9. Fairness

9.1 Fairness scenarios

This subclause attempts to show that the current fairness protocols have not adequately addressed the possible effects of classC traffic on (intended to be) higher precedence classA and classB traffic. The subannex is formatted for inclusion in Clause 9, for the convenience of the reader. This contribution editor is primarily concerned with clarity, correctness, and availability. The final placement of this content could be Clause 9, an annex, or a working-group presentation.

Figure 9.1—ClassA0 blockage scenario

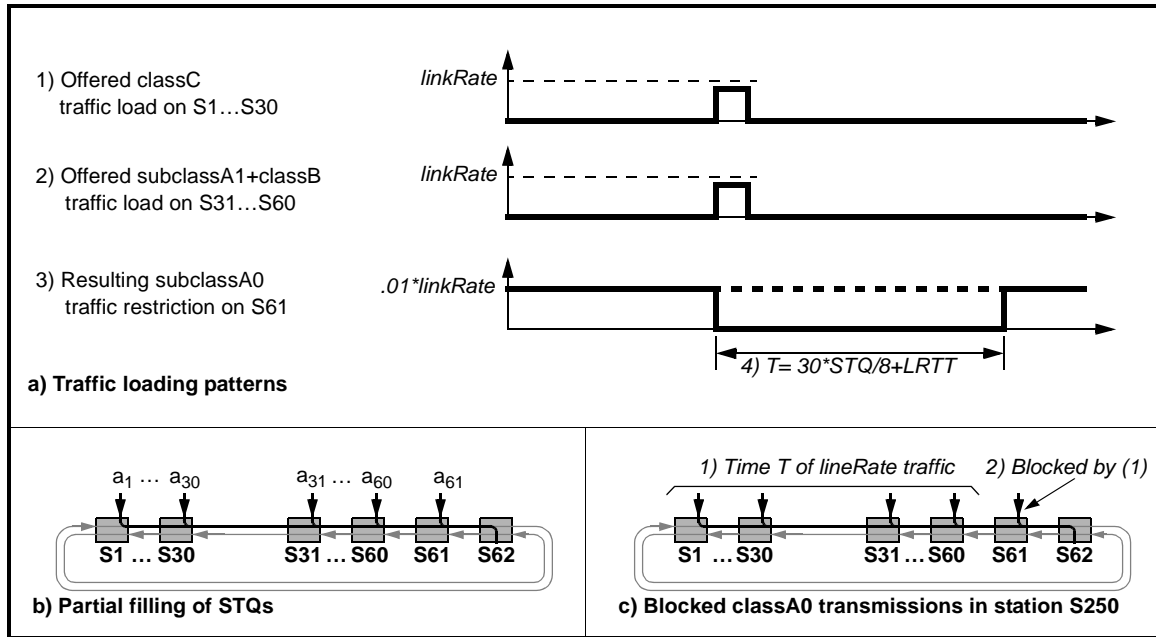
To illustrate potential STQ filling problems, consider the traffic loads of Figure 9.1a applied to topology of Figure 9.1b, leading to the classA0 bandwidth guarantee failure of Figure 9.1c. For this illustration, assume:

With an unfortunate timing of the offered $a_{31} \dots a_{60}$ add traffic, their STQs can fill to the low threshold (1/8 of the STQ) before a congestion condition is communicated. An additional delay of LRTT occurs before the cumulative upstream classC traffic from $a_1 \dots a_{30}$ can be stopped. As a result, the cumulative fill levels of the S31...S60 queues equals a time duration $T = 30 * STQ / 8 + LRTT$.

Because there is no downstream shaper on the STQs of stations S31...S60, these stations continue to transmit at the *linkRate* until their STQs have emptied. Thus, the downstream single-queue S61 station is blocked for at least the duration T , which directly effects the worst case classA0 traffic jitter. The LRTT delays are significant; for large buffer sizes, the STQ related delays become intolerable.

The classA0 blockage was caused by the partial filling of upstream STQ buffers, allowing the upstream stations to effectively exempt the transiting traffic from downstream shapers. Two types of solutions are therefore possible:

- a) Revise the transmission protocols, so that upstream STQs are never filled.
- b) Improve the effectiveness of the downstream shaper, so that STQ traffic is no longer exempted.

The viability of a type (b) solution and validation proofs are manageable. The downstream shaper is applied to all conflicting traffic: STQ and added classB, in addition to added classC. There is no need to limit the added classA1 traffic, since subclassA0 and subclassA1 traffic have equal precedence.
